29er

ADDITION TO CLASS RULES Rule C 10.3 (a) vi

Change from 8th January 2019

MAINSAIL DIAGRAM

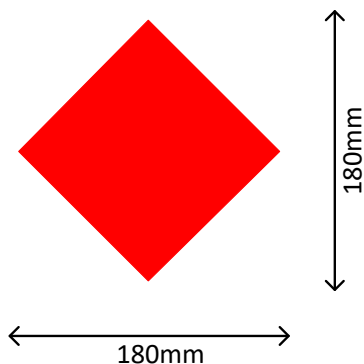
Mainsails used by all women crews shall carry a red rhombus (length of diagonals – maximum 190mm, minimum 170mm) just below the 2nd batten from the top of the mainsail and shall be placed on both sides of the sail, superimposed, above the Country code, minimum 60mm from the leach. The Notice of Race may change this rule.
